Class 2 Permit Modification Request

Addition of a Shielded Container

**Waste Isolation Pilot Plant
Carlsbad, New Mexico**

WIPP Permit Number - NM4890139088-TSDF

Figure A1-37
Typical Shielded Container

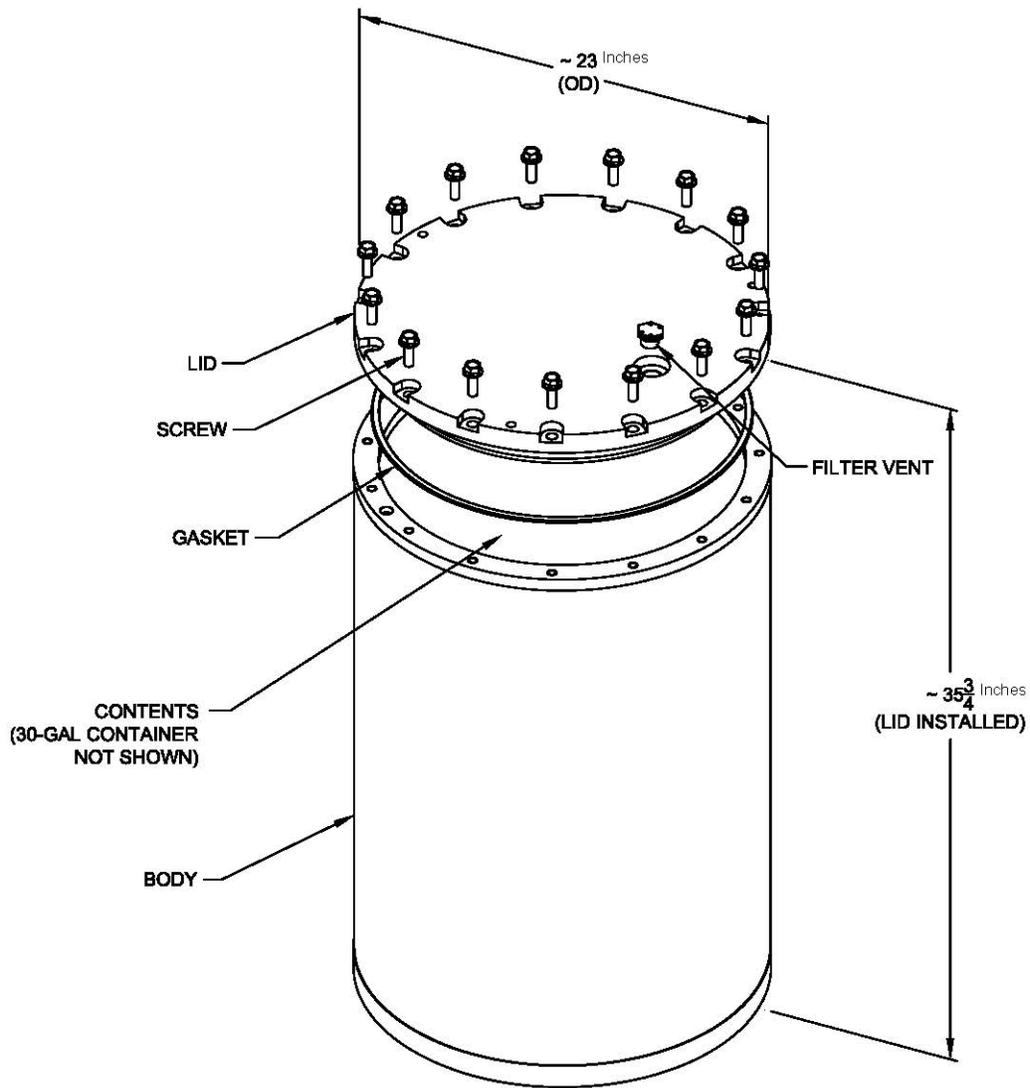
3. Add a figure of the shielded container (Figure A1-37).
4. Add "Shielded Containers" to Attachment C1, Sections C1-1a and C1-1a (1) and revise Table C1-8 indicating that the 55-gallon drum DAC bounds the shielded container.

Attachment A1, Table A1-2	Revise Table A1-2 to add shielded containers.	B-7
Attachment A1, Figure A1-37	Add “Figure A1-37 Typical Shielded Container”	B-8
Attachment A2, Section A2-2a(1)	Add “two 3-packs of shielded containers” Delete “or”	B-9
Attachment A2, Section A2-2b	Add “and shielded containers” Delete “(e.g., TRUPACT IIs or HalfPACTs),” Add “one 3-pack of shielded containers” Add “or shielded containers”	B-9
Attachment A2, Table A2-1	Revise Table A2-1 to add shielded containers.	B-10
Attachment A4, Section A4-3	Add “one 3-pack of shielded containers,” Add “two 3-packs of shielded containers,”	B-11
Attachment C1, Section C1-1a	Add “and shielded containers”	B-12
Attachment C1, Section C1-1a(1)	Add “and shielded containers” Delete “and” Add “,and shielded containers”	B-12,B-13
